Your Ref: PA/2025/815

Subject: Planning permission to install a 3m wide tarmac track around the perimeter of the existing sports field to enable the testing of electric cars

Location: Baysgarth School, Barrow Road, Barton upon Humber

Date: 27 August 2025

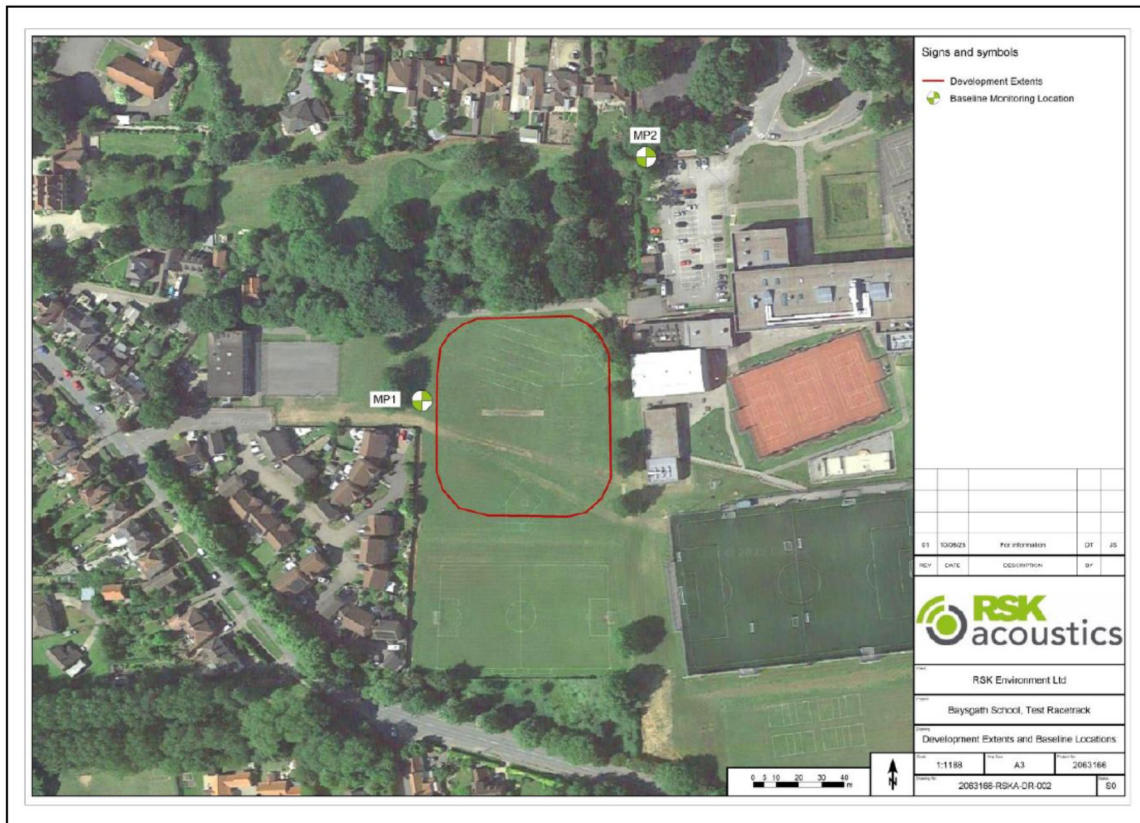
The noise report was carried out to assess the impact of the noise from the operational race track on noise sensitive receptors (NSR), shown below:

- No details of the proposed wooden boundary fence have been included in the assessment. Due to the proximity to residents on the western boundary, this department recommends the inclusion of an acoustic fence at this location to ensure residents are not impacted by activities associated with the track, which may include human activities in addition to the kit cars assessed.

4. Prior to the operation of the development hereby permitted, an acoustic barrier shall be erected on the west boundary of the test racetrack hereby permitted. A detailed technical specification of the acoustic barrier or wall shall be submitted to and approved in writing by the local planning authority. The specification shall include details of the location, size and design of the barrier, with predicted noise reduction over the frequency spectrum. The approved acoustic barrier or wall shall be installed prior to commencement of the use of this site and shall be maintained thereafter.
